RIDE THE DUCKS INTERNATIONAL
Fleet Operations & Safety
2320 West Highway 76
Branson MO 65616

Bulletin No. SB-00-09-13
Release Date: 5/6/13
Effective Date: 5/6/13
Supersedes: N/A
Completion Date: **Immediate**
Applicable to: All Diesel Truck
Ducks
Total Pages: 3

SERVICE BULLETIN

REASON FOR RELEASE: Modification to mitigate the potential sticking of the Truck Duck diesel powered hand throttle cable and foot pedal.

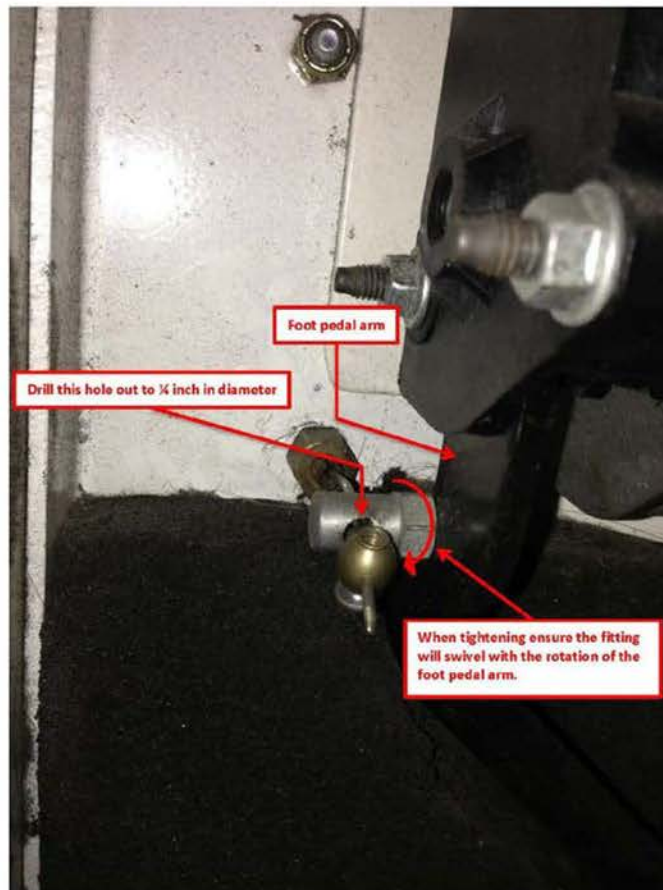
This modification consists of a simple enlargement of an existing drill hole in which the hand throttle cable runs through. This cable is tied to the foot throttle pedal. See Figure on (page 2)

1. Locate the hand throttle cable within the engine bay near the low portion of the fire wall and connected to the foot throttle pedal arm.
2. Remove the linkage from the foot pedal arm and enlarge the drill hole that the cable runs through (drill out ¼" diameter)
3. When reinstalling and tightening the drilled linkage to foot pedal arm, ensure the linkage will swivel with the rotation of the foot pedal arm.

Note: The results of this modification allows the cable to freely maneuver through the linkage hole without sticking.
